**No. 85-36**

## A. OVER-TRAVEL SHIFT CONDITIONS ON MR DRIVE UNIT

Figure 1.

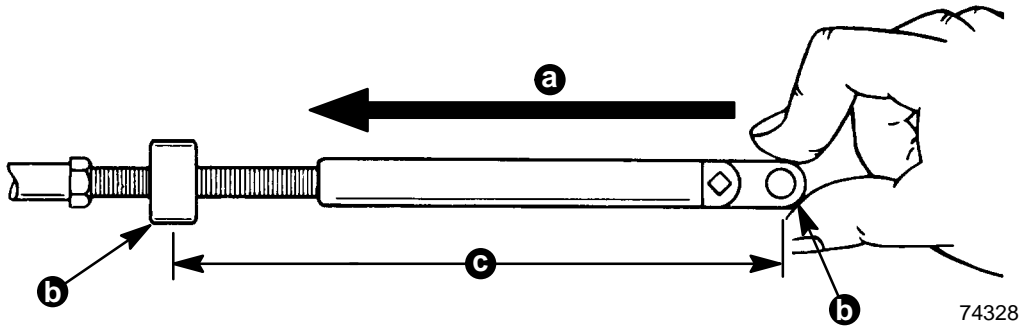
1. Check drive unit shift cable dimension with the unit shifted into forward gear (Figure 1).

- ▲ 2. If the above dimension is less than 6", Refer to **Service Bulletin 89-4**
